**Attachment B: Records of Changes to Final Design Submission
Packages**

North Texas OAPM Design Package

DFW SIDs, HUDAD, HRPER, KATZZ, ALIAN and WSTEX DFW RNAV SIDs

RECORD OF CHANGE

Figure 2. Proposed BOOVE and SOCKK RNAV STARs and JEN STAR (Will replace Figure 3 of PFD)

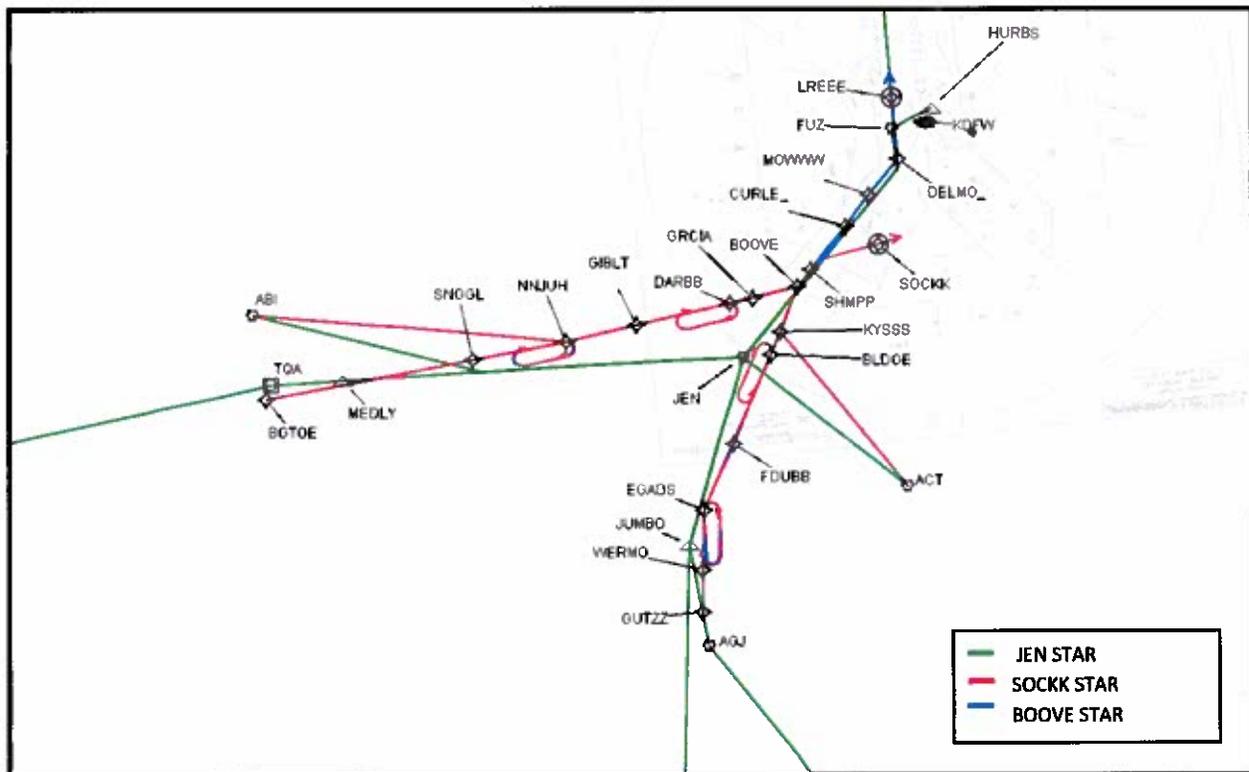
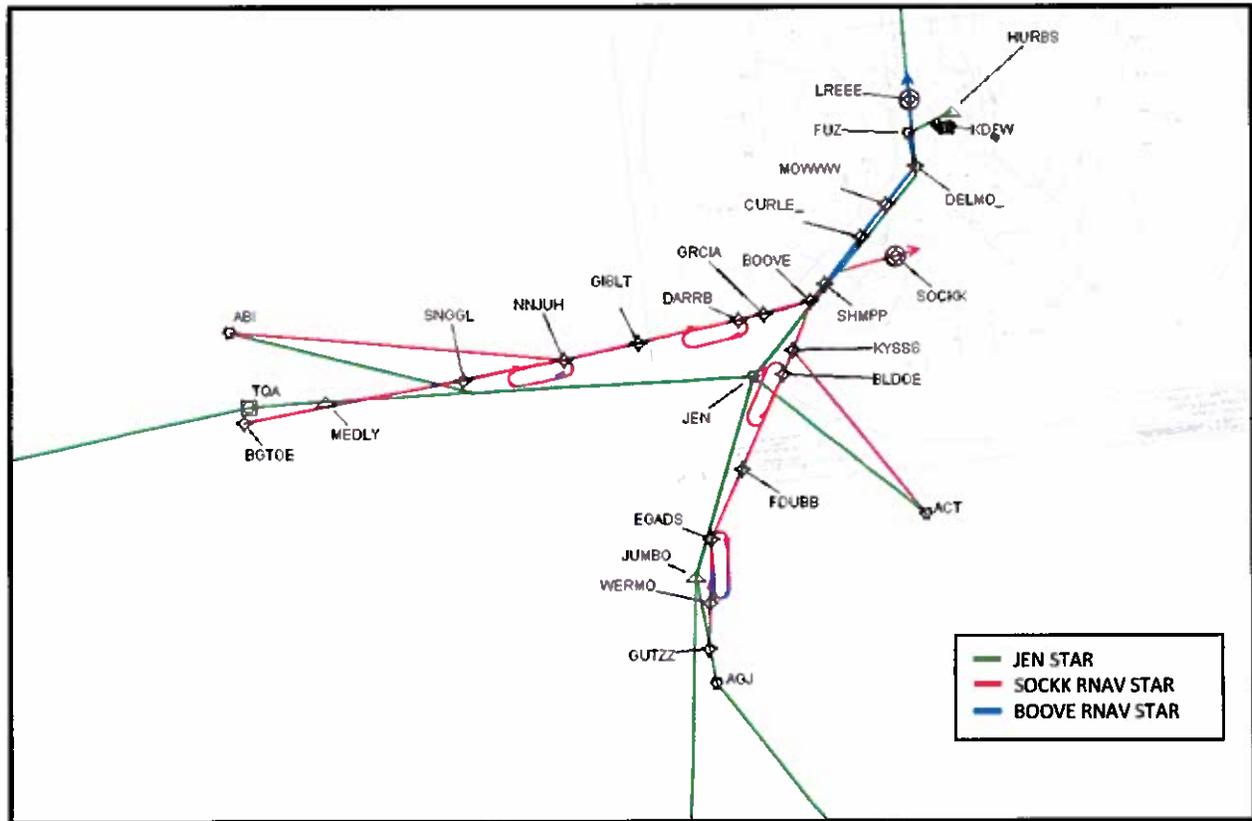
On the BOOVE and SOCKK RNAV STARs, DARBB waypoint was renamed DARRB waypoint due to waypoint name reservation availability.

Figure 2 below replaced Figure 3 in the PFD.

Figure 2. Proposed BOWIE STAR and Current BOWIE STAR (Will replace Figure 1 of PFD)

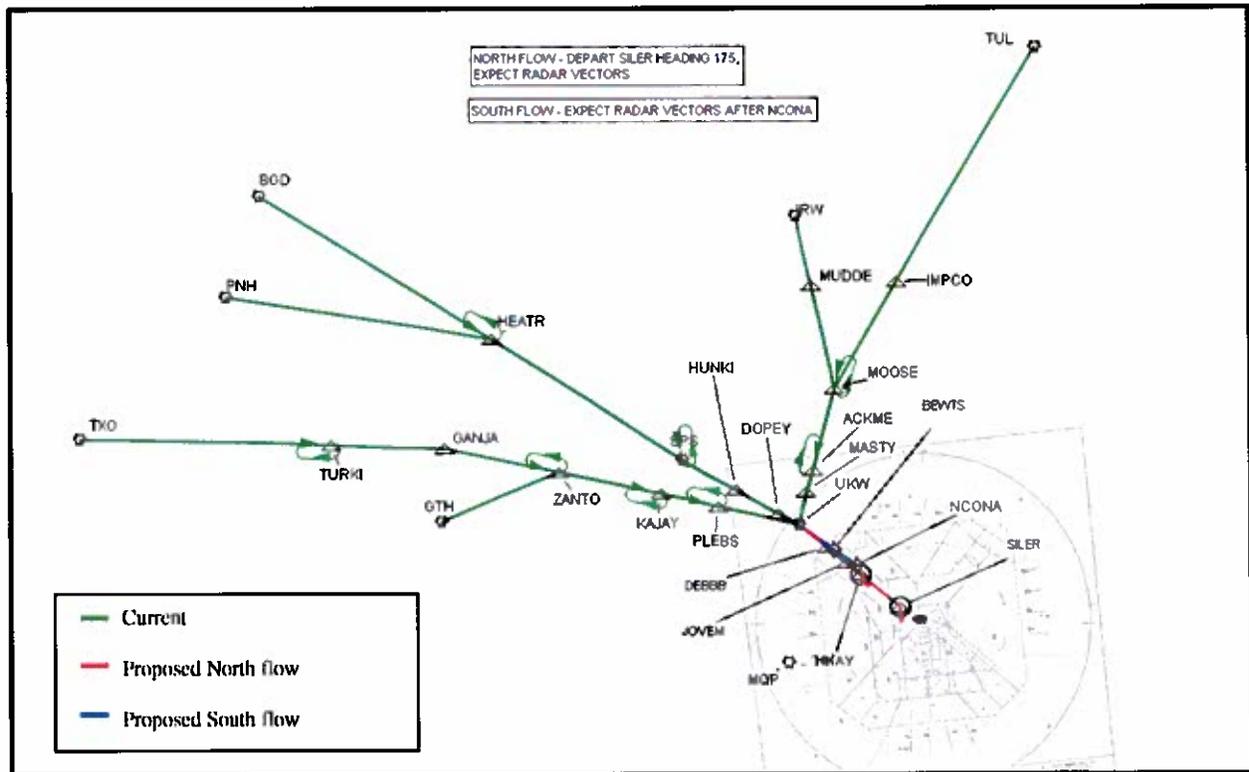
On the BOWIE Conventional STAR, in Figure 1 holding patterns were added at MOOSE, ACKME, PLEBS, KAJAY, ZANTO, TURKI and HEATR waypoints and SPS VORTAC. These changes are due to incorrect TARGETS files initially used.

Figure 2 below replaced Figure 1 in the PFD.

Figure 2. Proposed CAINE and DAWGZ RNAV STARS (Will replace Figure 3 of FD)

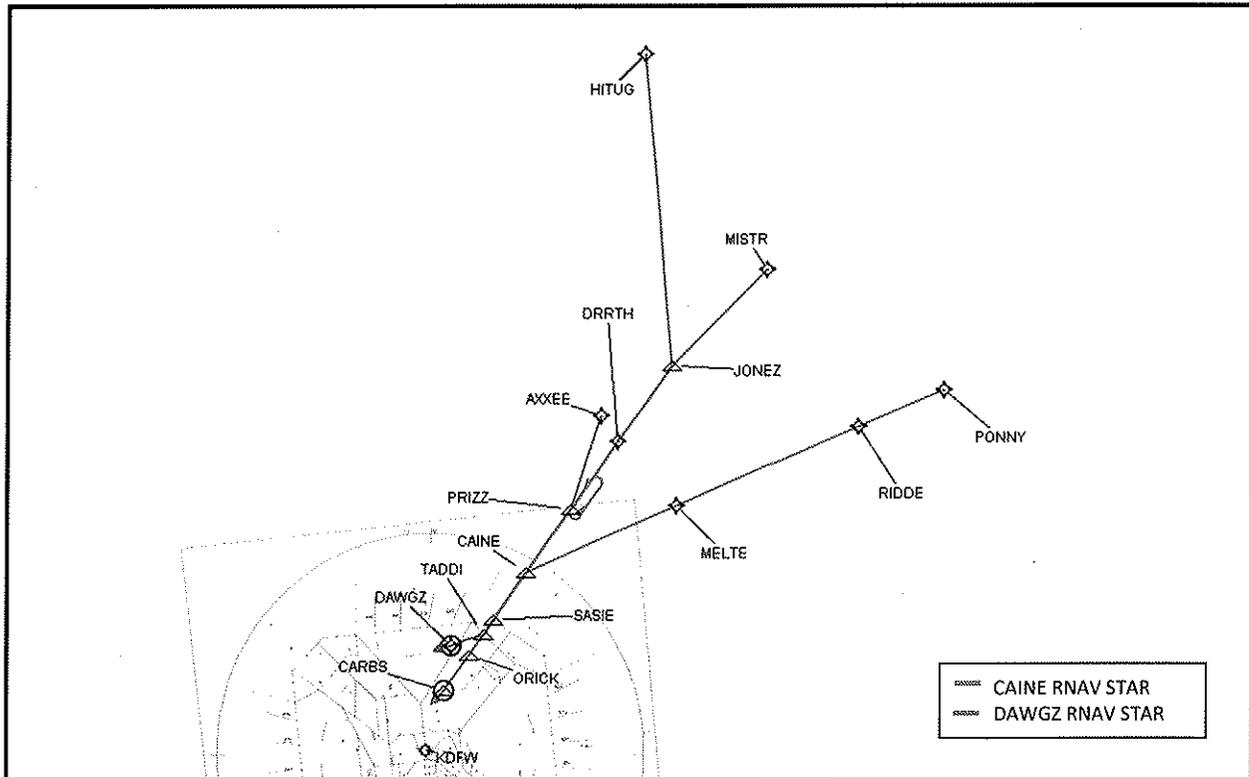
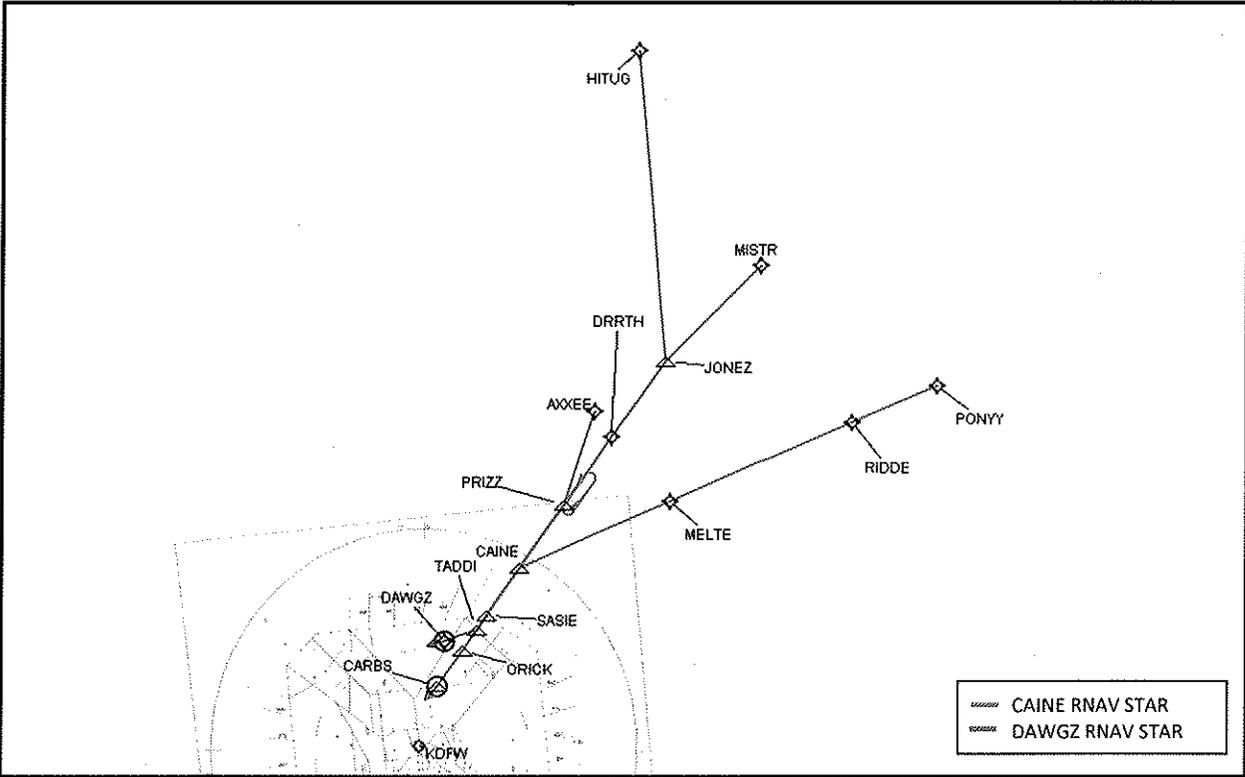
On the CAINE and DAWGZ RNAV STARS, PONNY waypoint was renamed PONYYY waypoint due to waypoint name reservation availability.

Figure 2 below replaced Figure 3 in the FD.

Figure 2. Proposed RNP-AR to RWY13L/R (Will replace Figure 3 in FD)

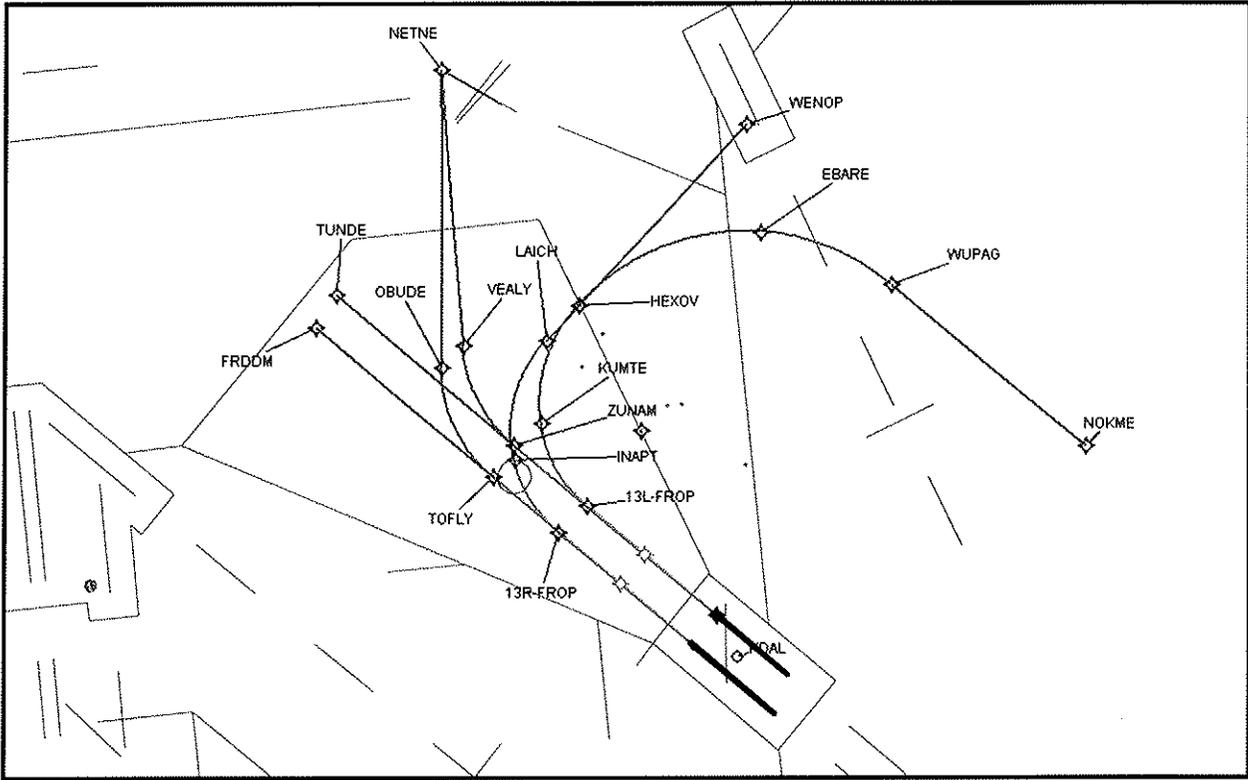
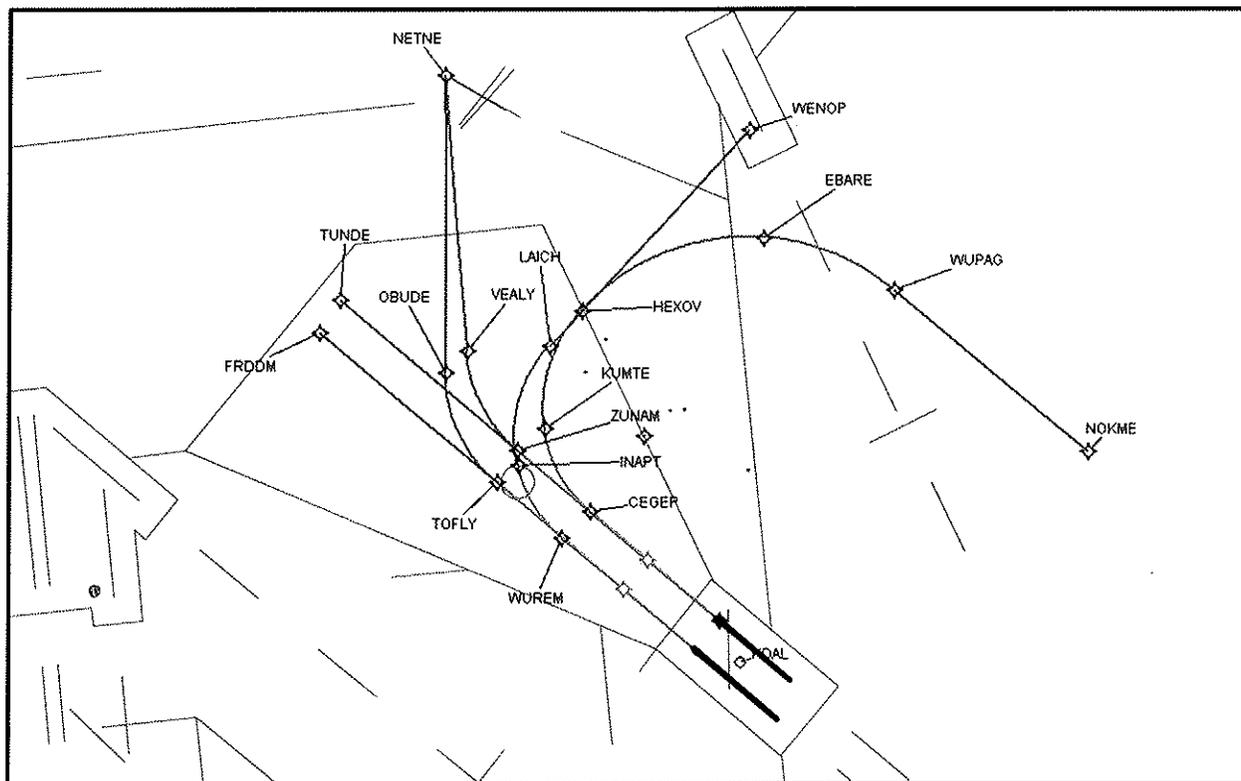
The Threshold Crossing Height for DAL Runway 13L was raised from 35.2 feet to 40.2 feet. (5 feet total) This resulted in movement of the following waypoints and arcs.

<u>Waypoint name</u>	<u>Amount of movement</u>
EBARE	21.93 FEET
HEXOV	5.97 FEET
LAICH	29.98 FEET
WUPAG	9.02 FEET
VEALY	8.59 feet
TUNDE	95.4 feet closer to rwy
ZUNAM (PFAF)	95.47 feet closer to rwy

The Runway 13L Final Rollout Point (FROP) was named CEGEP waypoint. The Runway 13R FROP was named WUREM waypoint.

Figure 2 below replaced Figure 3 in the FD.

Figure 1. Proposed FINGR STAR and Current FINGR STAR (Figure 1 of PFD)

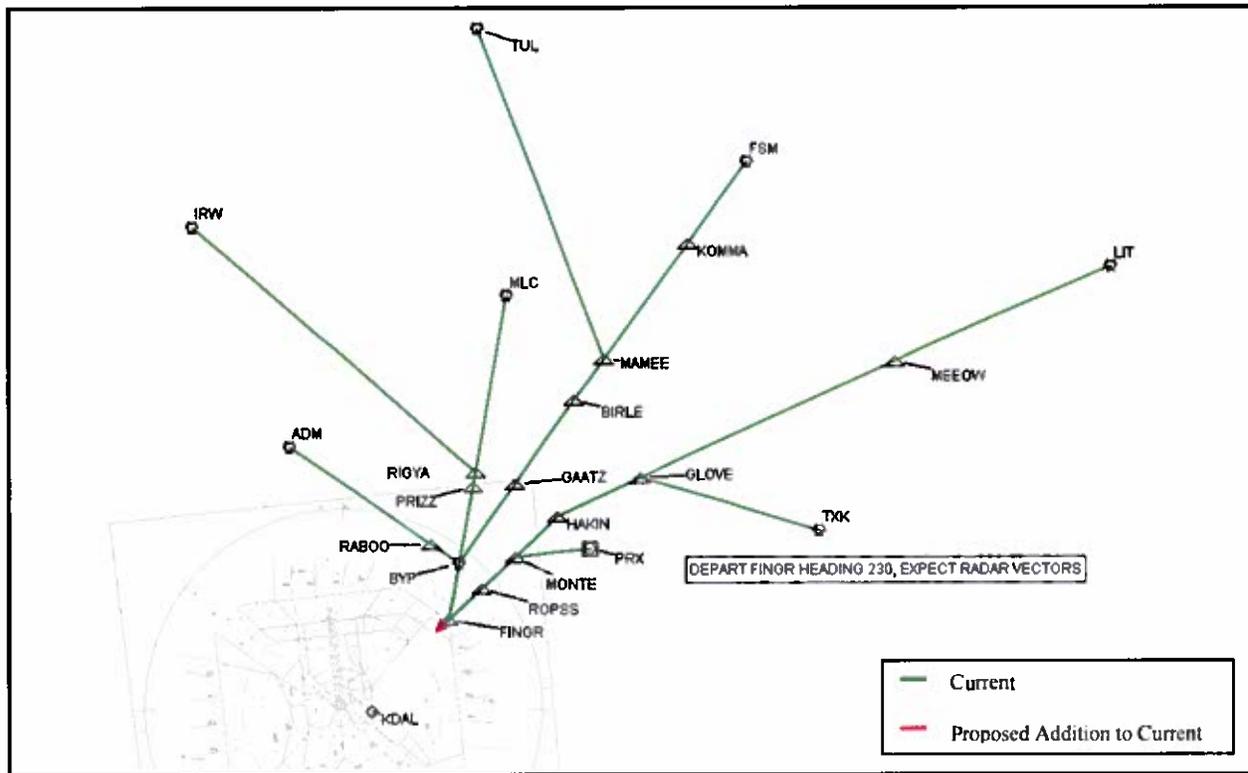
On the FINGR Conventional STAR, in Figure 1 holding patterns were added at GLOVE, BIRLE and GAATZ waypoints and BYP VORTAC. These changes are due to incorrect TARGETS files initially used.

Figure 2 below replaced Figure 1 in the PFD.

Figure 2. Proposed FORNY and CABBY RNAV STARS and JAGGO THREE STAR (Will replace Figure 3 in PFD)

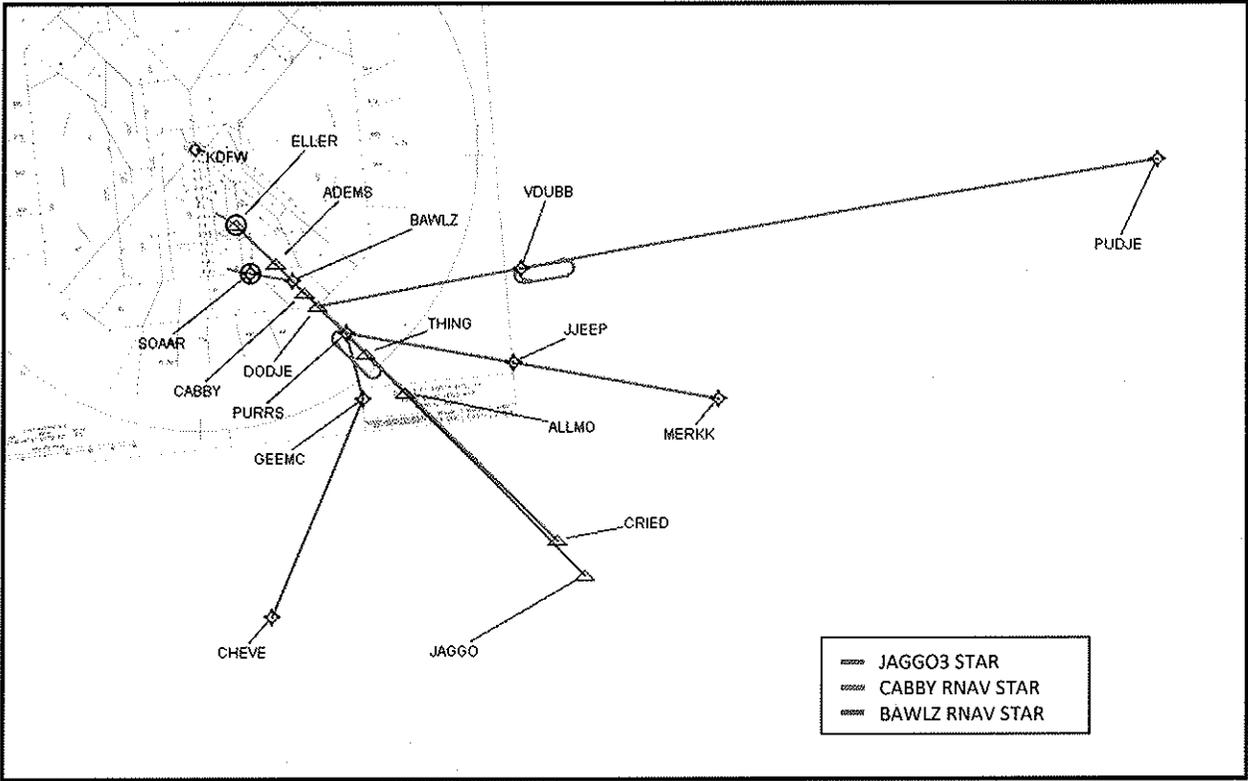
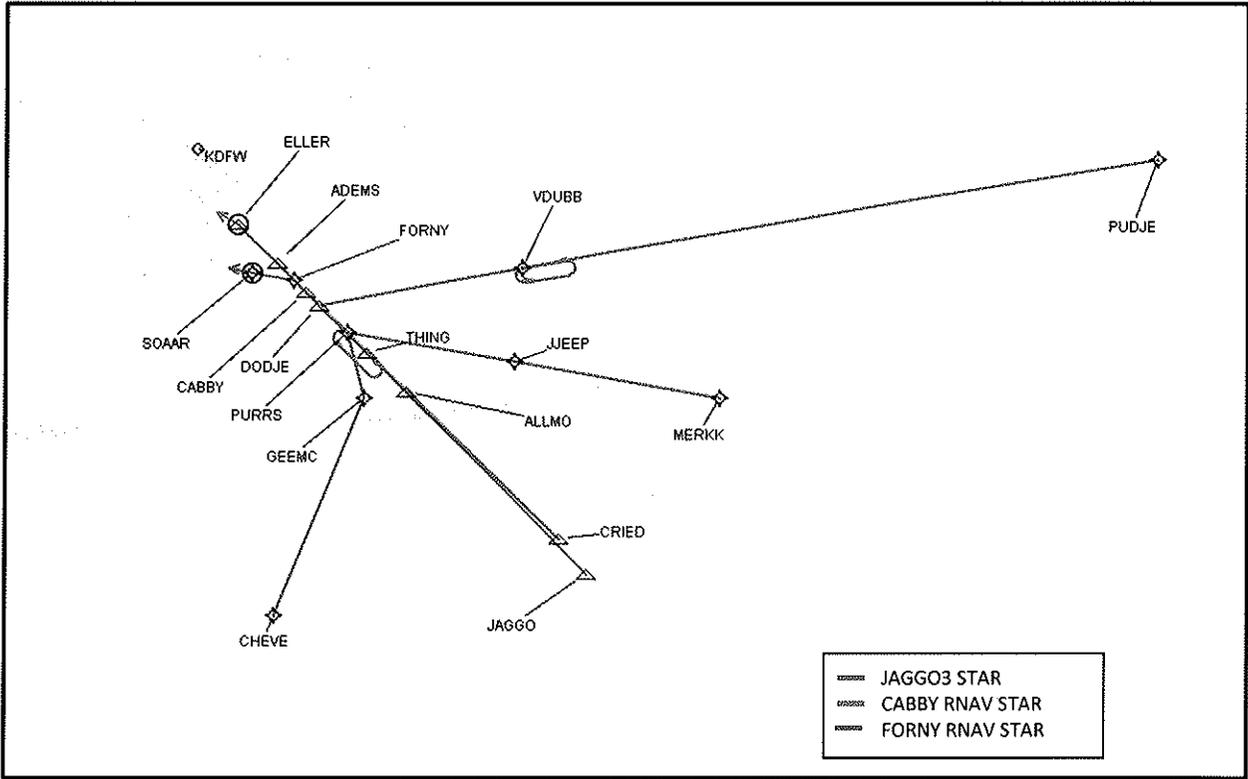
On the BAWLZ RNAV STAR, BAWLZ waypoint was renamed FORNY waypoint due to questionable appropriateness of the name. Therefore, the BAWLZ RNAV STAR was renamed the FORNY RNAV STAR.

Figure 2 below replaced Figure 3 in the PFD.

Figure 1. Proposed GLEN ROSE STAR and Current GLEN ROSE STAR (Figure 1 of PFD)

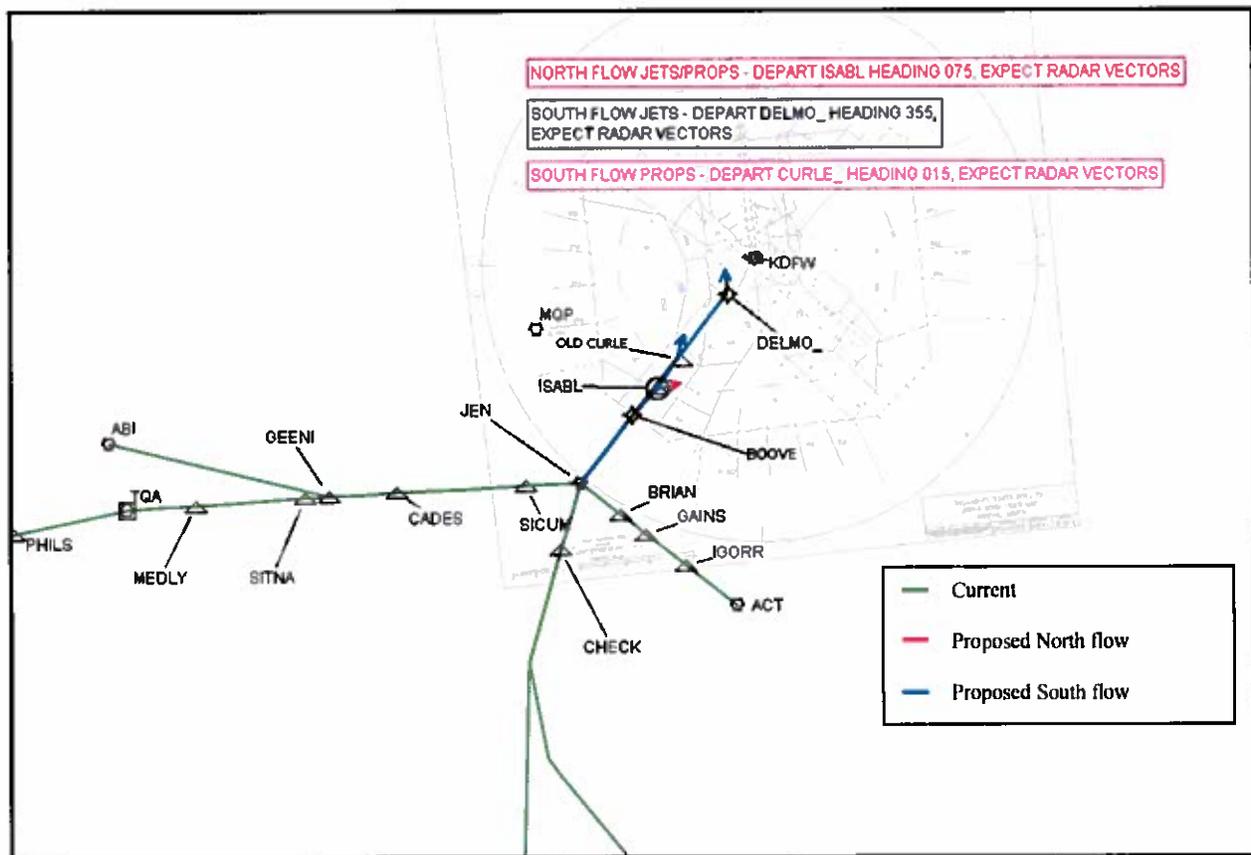
On the GLEN ROSE Conventional STAR, in Figure 1 holding patterns were added at PHILS, CADES, JUMBO, CHECK and SICUM waypoints, and BROWNWOOD (BWD) and JEN VORTACs. These changes are due to incorrect TARGETS files initially used.

Figure 2 below replaced Figure 1 in the PFD.
